REMARKS/ARGUMENTS

The Examiner noted applicant's election of Group I claims for examination, and indicated that claims 25-31 and 34 had been withdrawn from further consideration. In response all of the withdrawn claims, claims 25-31 and 34 are being cancelled without prejudice, with the exception of claims 28 and 30. Claims 28 and 30 are being amended to make them dependent from claim 3, so that they now may be properly included within the Group I claims.

FIG. 8

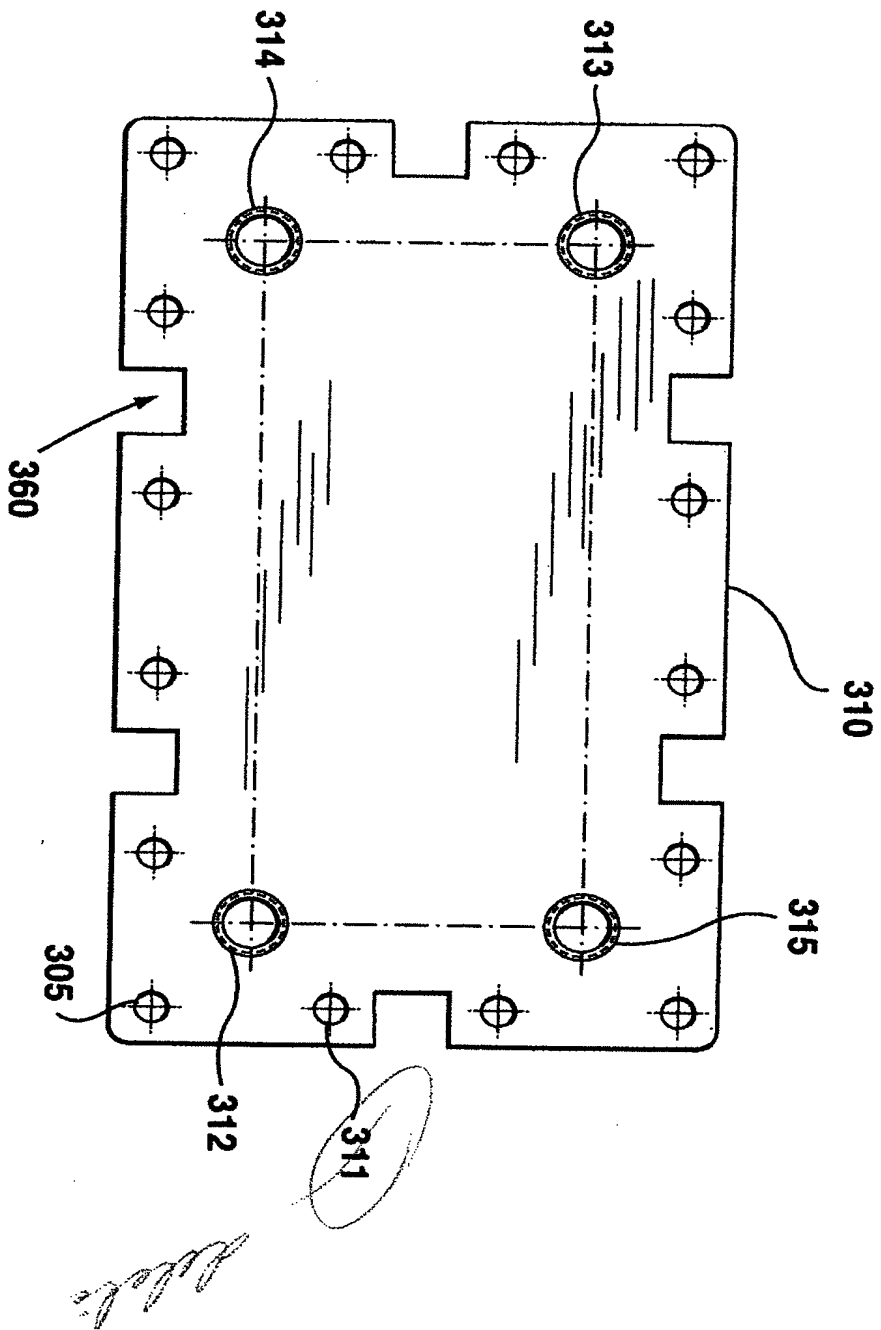
With respect to the objection to Figure 8 under 37 C.F.R. 1.84(p)(5), this drawing has been amended to provide the reference 360.
